SS 1034761 P3 - CEL On and Engine de-rate due to ATD Chassis Harness Circuit 532M5+ at DEF Heater Supply location is shorted

FTL P3 - Cascadia

DETAIL -633
BACKSHELL (-633 THRU -639 SHOWN)

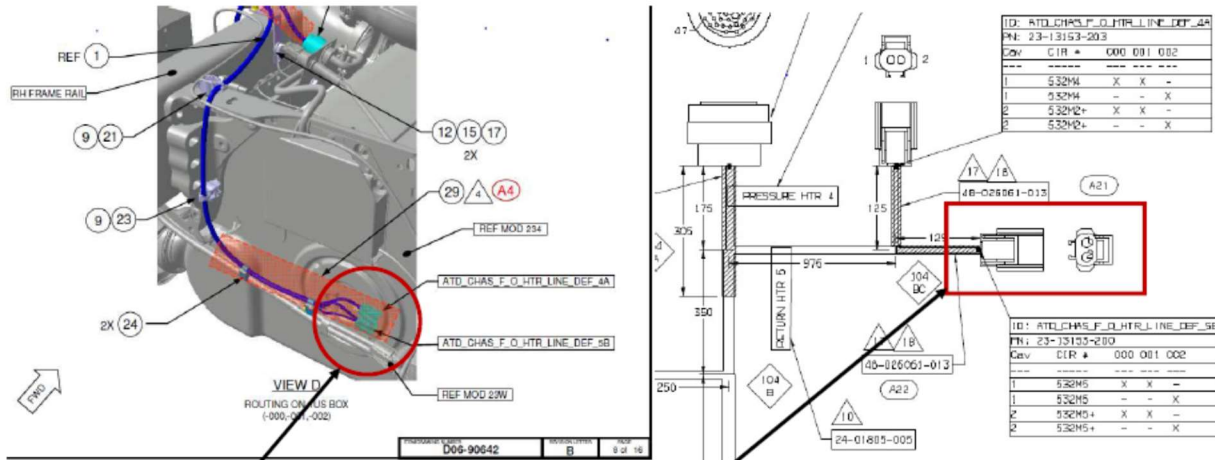
Harness part number A66-03217-002 has been reported experiencing failures due to damages to 532M5+ circuit shorting /or corrosion in terminals at Connector (23-13053-200) harness location "ATD_CHAS_F_O_HTR_LINE_DEF_5B" .

Connector backshell is available to be added at the location indicated to add extra protection to wiring and also reduce or eliminate terminal corrosion.

Required part number: 23-13302-633 -- Backshell

Addition of Back Shell 23-13302-633 to Connector 23-13153-200in ATD Chassis Harness A66-03217-002
